Preface

This document is an update to the specifications contained in the Affected Documents/Related Documents table below. This document is a compilation of device and documentation errata, specification clarifications and changes. It is intended for hardware system manufacturers and software developers of applications, operating systems, or tools.

Figure 1. S_Clock Multiplexer Workaround Circuit for Errata 6.

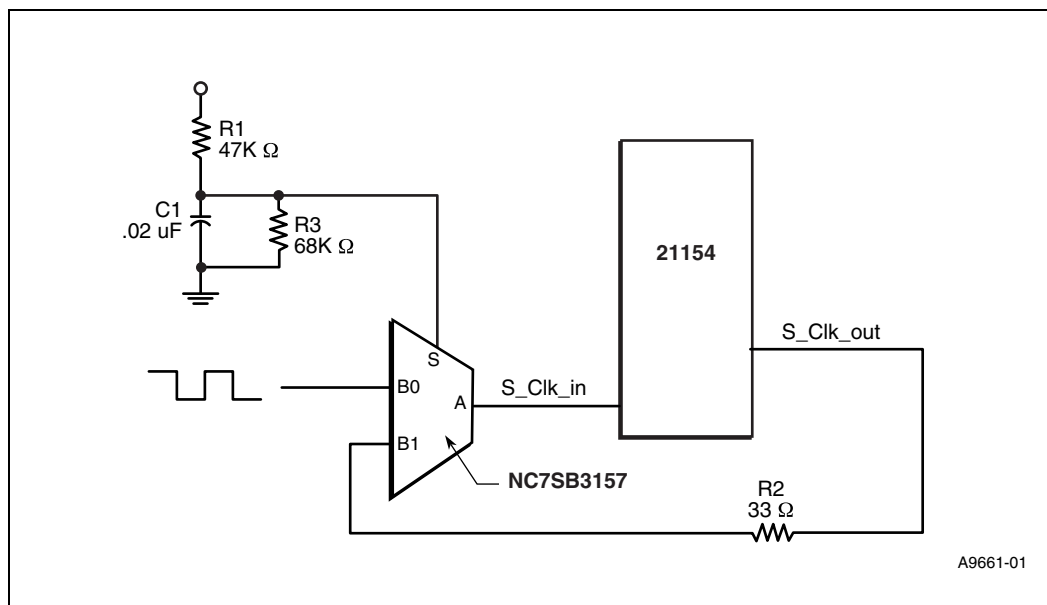
6. Secondary Clocks Outputs s_clk_o<9:0> May Not Start-up Properly Under Some Conditions

Problem: This problem has been found on the 21154AC and 21154BC. Under repeated and frequent power cycling, the secondary clock circuits may not power up in the proper state, resulting in the device not coming out of reset after power up.

Implication: In a system with a 21154AC or 21154BC that has one of its s_clk_o<9:0> outputs fed back to provide the s_clk, it is possible that the s_clk_o<9:0> output clocks will be driven and remain low, keeping s_rst_l asserted, during system power up.

1. [Figure 1](#) illustrates the first recommendation - a circuit where an on-board pulse source is gated via the B0 input of the multiplexer to the S_Clock_in pin of the 21150.

At time 0, the S input of the multiplexer is low, allowing pulses from the on-board pulse source, connected to the B0 input, to be provided to the 21150 S_Clk input pin. When the time determined by the R/C network is satisfied, the S input pin will be in a logic High state. The multiplexer will then shut off the input pulse from S0 and will direct the S_Clock_out pulses via the B1 multiplexer input, into S_Clock_in

The values used for the R/C network should be selected to allow a minimum of 2 pulses to be delivered to the 21150 after Vdd has reached 3.0V at a frequency not to exceed the appropriate PCI component. i.e. 30 ns for a 33Mhz bridge. These values should be chosen based on the rise time of the power supply and the frequency of the on board pulse source. The values given for R1, R3, and C1 are for example purposes only.

Note: The NC7SB3157 2:1 Multiplexer / Demultiplexer Bus Switch used in this example has a maximum propagation delay of 800ps that should be taken into consideration when matching trace lengths of the clock lines to avoid introducing excessive skew in the clocks. All S_Clock etch lengths must be matched to within 2ns @ 33Mhz or 1ns @ 66Mhz. The addition of this circuit requires that the etch length for the S_clock_in signal be reduced to compensate for the 800ps delay.

Figure 2. Recommended Circuit for a Tristable Buffer

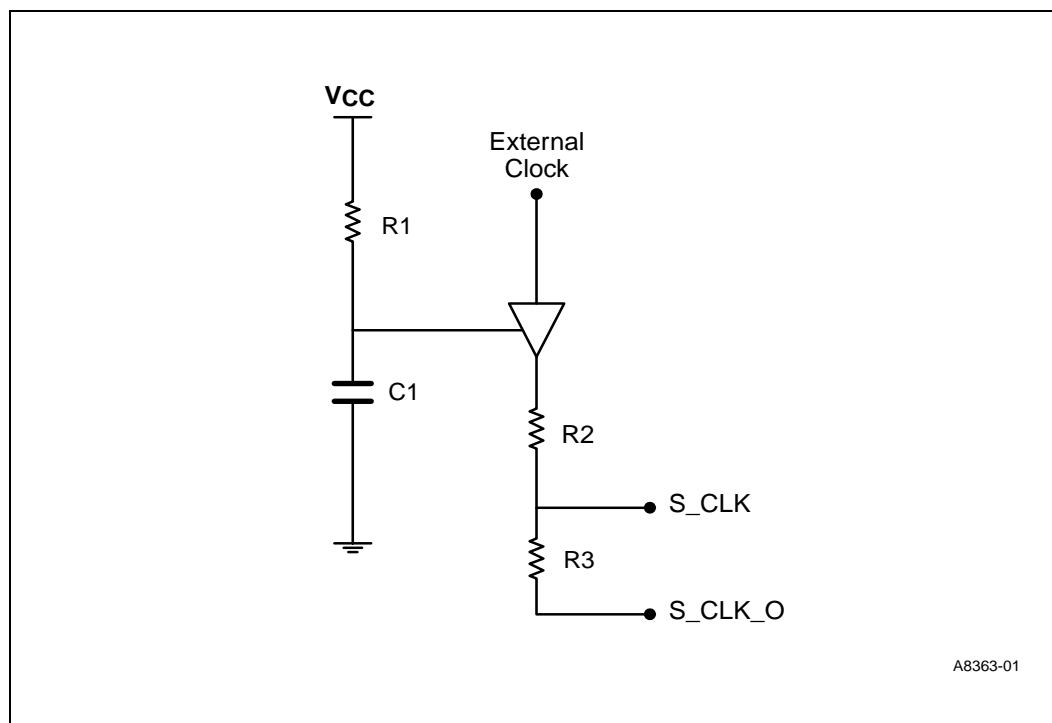
2. In the second recommendation, to guarantee the proper initialization of the **s_clk** circuits, the addition of an external circuit that provides a minimum of two transitions on the **s_clk** input during the power-up ramp is necessary. This can be done using a solution that drives an external clock onto the **s_clk** input while 3.3V Vcc is ramping during power up.

Figure 2 illustrates the use of a tristable buffer to provide multiple pulses to the **s_clk** input. The Vcc ramp rate and R1,C1 time constant determine the duration and amplitude of the pulses generated during power up. The R2-R3 values are chosen based on applicable board etch impedance-matching requirements.

The following should be considered in calculating the R1,C1 time constant:

- Make the time constant of the circuit as short as possible, while still ensuring that a minimum of two pulses are generated during the Vcc ramp.
- Phase delay between **s_clk_o** and the external clock should be minimized.
- Matching the external clock and **s_clk_o** frequencies to reduce contention.
- Laboratory experiments using **p_clk** as the external clock and a R1C1 time constant between 40 and 60 percent of the Vcc ramp have been successful using this configuration. However the use of **p_clk** as the external clock violates the PCI bus specification for loading of the primary clock.

Figure 6. Removal of Pull-Down Resistor for JTAG Testing

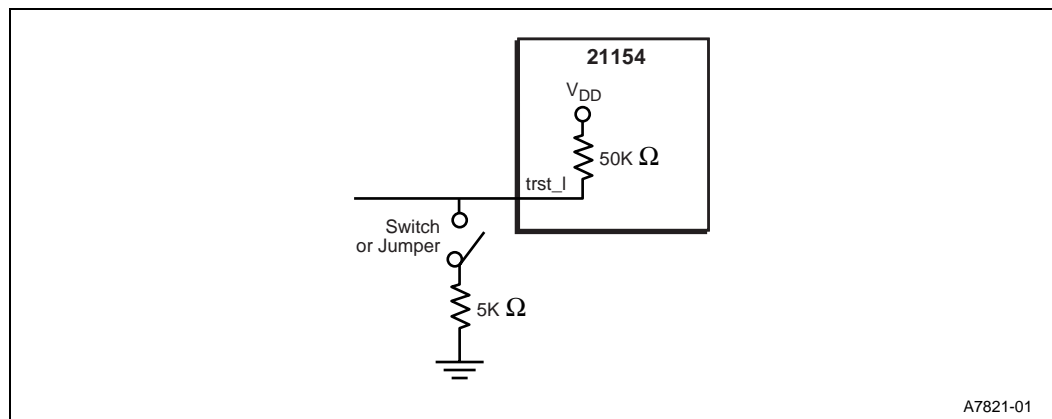
9. Section 6.3.1, Signal trst_l Pull-Down Resistor, New Section

A 5 K Ω pull-down resistor is required on trst_l for normal PCI-to-PCI bridge operation. However, some JTAG test results may be inconclusive if the 5 K Ω resistor remains in the circuit. To obtain accurate JTAG results, Intel recommends one of the following solutions:

- Verify that the JTAG test equipment, after driving trst_l low to reset the TAP controller, constantly drives trst_l high during JTAG tests. If this signal is not constantly driven high, the 5 K Ω resistor will pull the signal to a low state.
- Remove the 5 K Ω resistor during JTAG tests. This resistor must be installed during normal PCI-to-PCI bridge operation.
- Design external circuits with a switch or jumper to isolate the 5 K Ω resistor during JTAG tests (see Figure 6). This switch must enable the resistor during normal PCI-to-PCI bridge operation.

Figure 19 Example of GPIO Clock Mask Implementation on the System Board

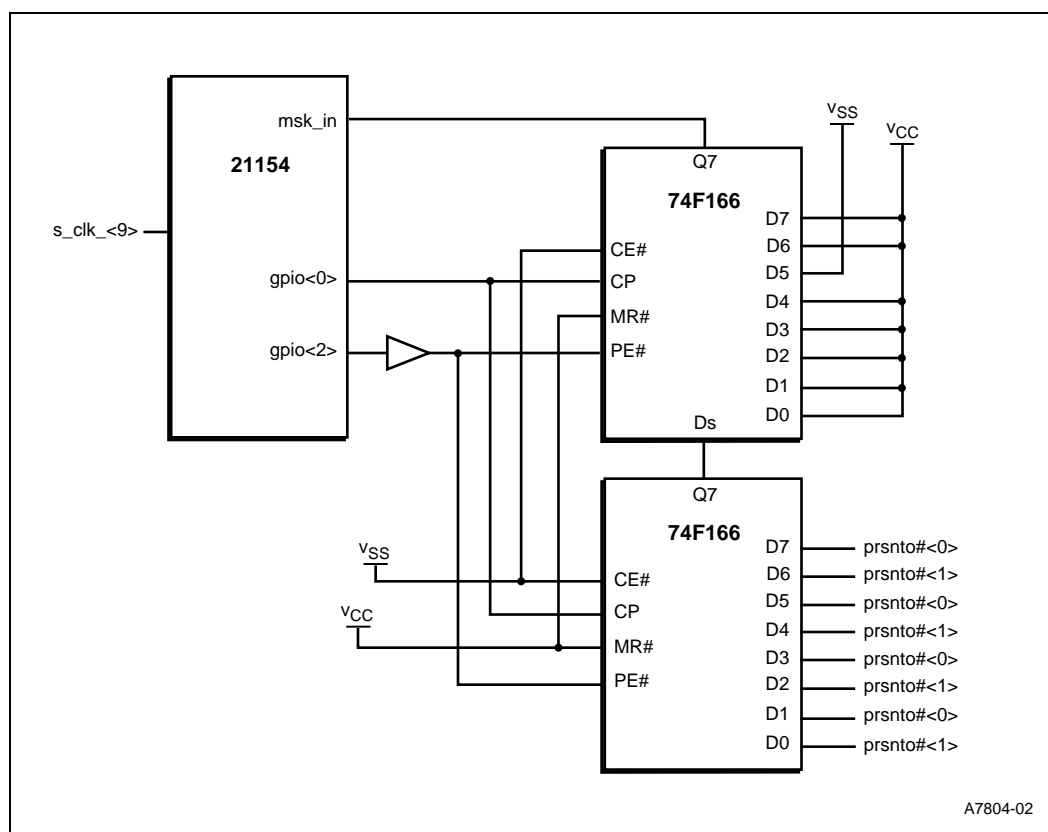
12. Section 10.2, Secondary Clock Control, Figure 19

This figure now appears as follows:

Figure 20. Clock Mask and Load Shift Timing

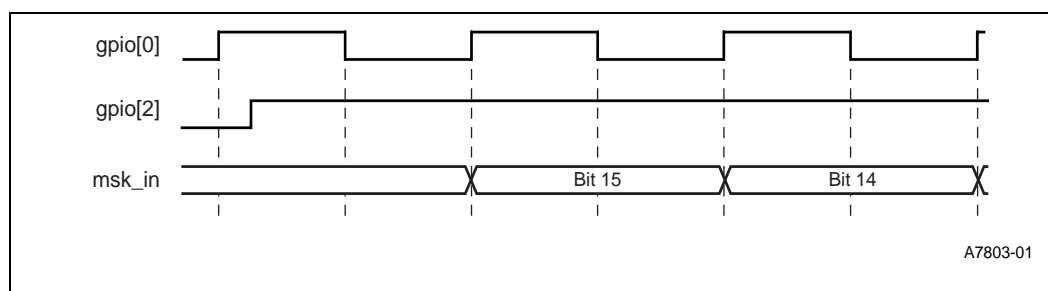
13. Section 10.2, Secondary Clock Control, Figure 20

This figure now appears as follows:

Figure 21. Clock Mask and Load Shift Timing

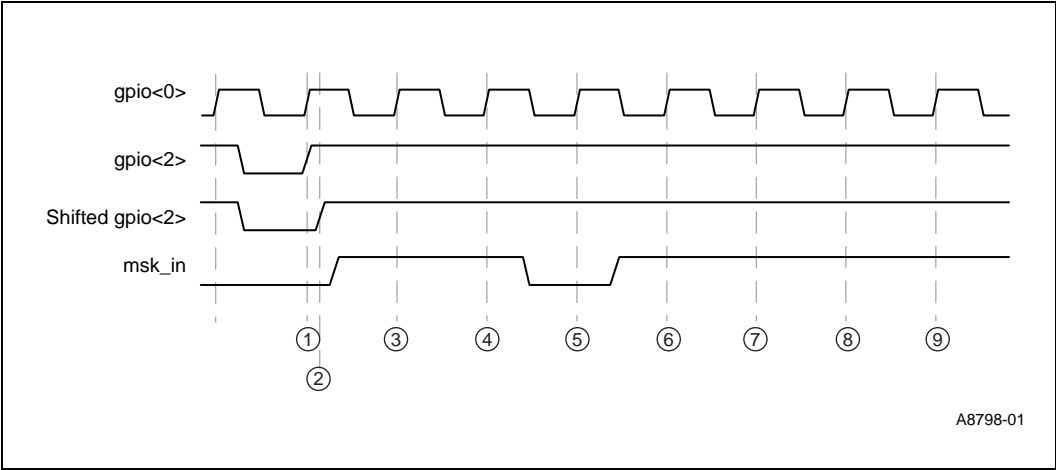
15. Section 10.2.1, Mask and Load Shift Timing Events for 66 MHz Operation

The following new section has been added:

The following list provides the timing sequence for 66 MHz operation for an example circuit as shown in Figure 19 and the timing diagram in Figure 21.

1. The **gpio<2>** original coming from the 21154 does not provide 3ns setup time needed to provide the parallel load enable **PE#** of the 74F166.
2. The shifted **gpio<2>** is delayed by ~9ns to provide ample setup time to enable the parallel of the shift register connected to pin 15 of the 74F166.
3. Bit 15 input **D6** of the shift register is pulled high, to Vcc.
4. Bit 14 input **D7** is pulled high, to Vcc. These signals are not used internally in the 21154.
5. Bit 13 **s_clk_o<9>** is a feedback to the 21154 **s_clk_o** input. To enable **s_clk_o<9>** in all cases the **D5** input of the shift register is grounded, to Vss.
6. Bit 12 **s_clk_o<8>** is disabled.
7. Bit 11 **s_clk_o<7>** is disabled.
8. Bit 10 **s_clk_o<6>** is disabled.
9. Bit 9 **s_clk_o<5>** is disabled.

Figure 3 Example of GPIO Clock Mask Implementation on the System Board

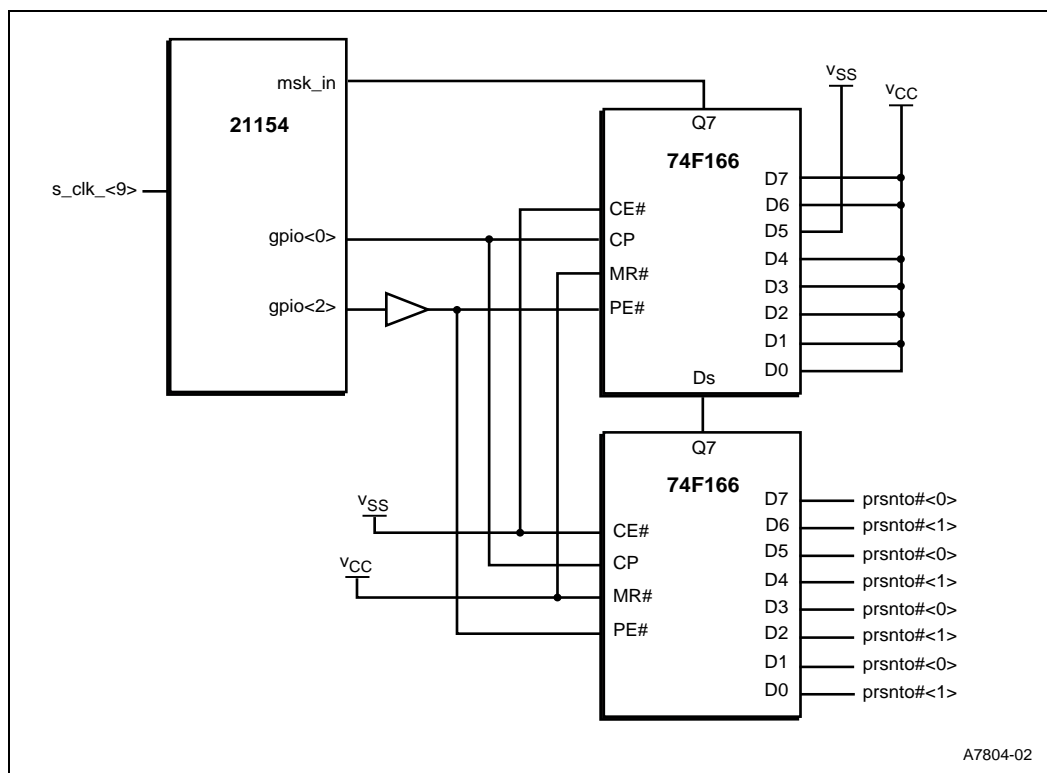
18. Section 4.4.1, Serial Clock Mask Shift, Figure 3

Figure 3 has been updated as follows:

Figure 4. Clock Mask Load and Shift Timing

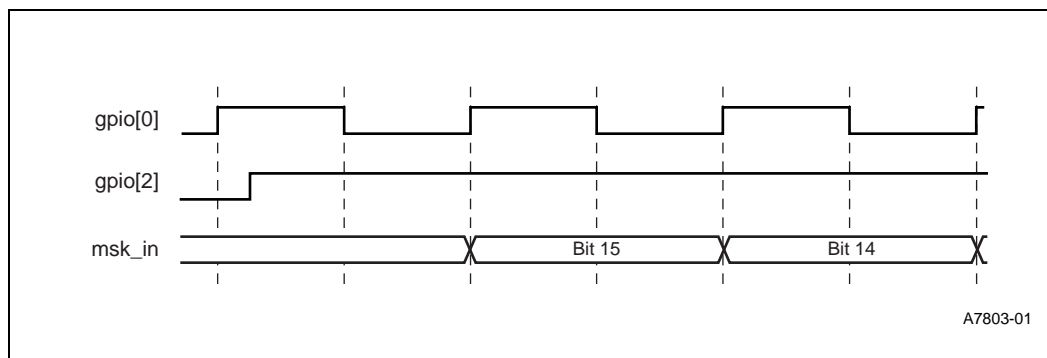
19. Section 4.4.1, Serial Clock Mask Shift, Figure 4

Figure 4 now appears as follows:
